City of El Paso – City Plan Commission Staff Report

Case No: PZRZ12-00026
Application Type: Rezoning
CPC Hearing Date: September 20, 2012
Staff Planner: Elizabeth Gibson, (915) 541-4730, gibson@elpasotexas.gov

Location: North of Montana Ave. and East of Airport Rd.

The applicant is requesting to rezone the subject property to SmartCode Zone (SCZ) to permit an Infill Airport Regional Center Development (RCD). An Infill Airport RCD is appropriate for urban core areas within one mile of the airport terminal or along the Montana Bus Rapid Transit Route. The attached regulating plan shows two pedestrian sheds, one long and one standard, with special district zone allocations SD3(Airport T5.1), SD4 (Airport T5.2), and SD5 (Airport ST). Due to the Federal Aviation Administration limitations on use in proximity to an airport, the application area cannot provide long-term residential uses. As a result, the previously mentioned three Special Districts were developed to permit a walkable, mixed-use, entertainment, employment, light industrial and tourist development in proximity to the El Paso International Airport. The application area's location along the proposed Montana Avenue Bus Rapi

Color Key	Thoroughfare
	CS-70-42
	CS-50-22
	CS-60-34
	SL-35

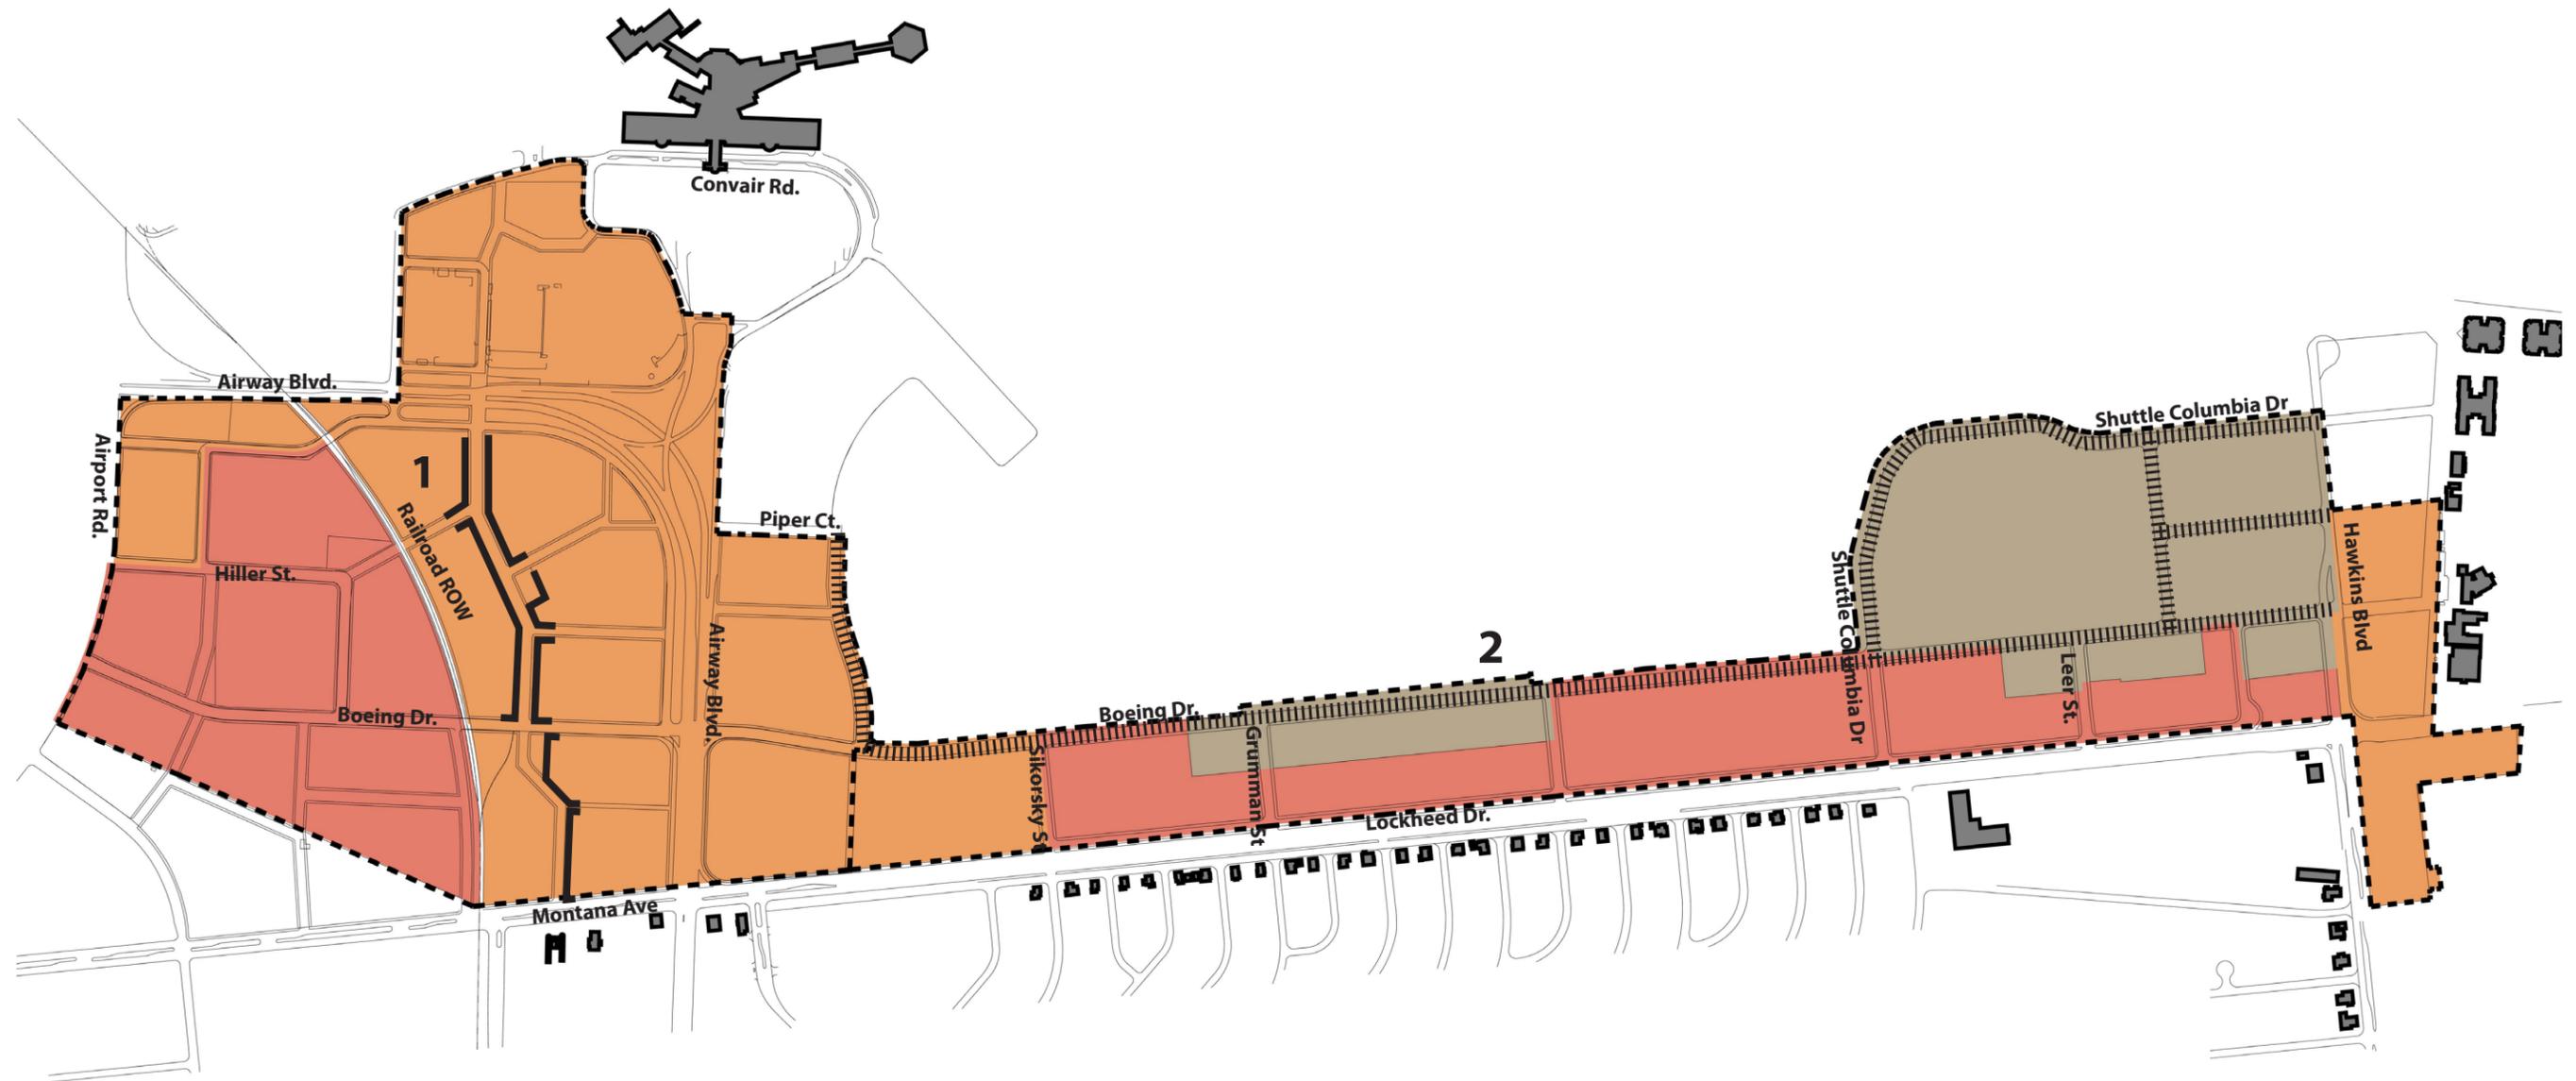
1. For the thoroughfares designated for transit use, increase the outside land width to 11 feet to allow for adequate and safe movement for the buses.

2. Sun Metro staff also reviewed the proposed roadway widths to the proposed possible transit routes in the Master Plan. The roadway widths proposed in the application are 10' which does not provide sufficient safety clearance for the buses traveling through the route. The proposed roadways also are showing on-street parking thus making the 10' travel path a greater safety concern. Sun Metro staff recommends 11' travel paths are used in the design of the streets where possible transit routes have been identified by the Master Plan.
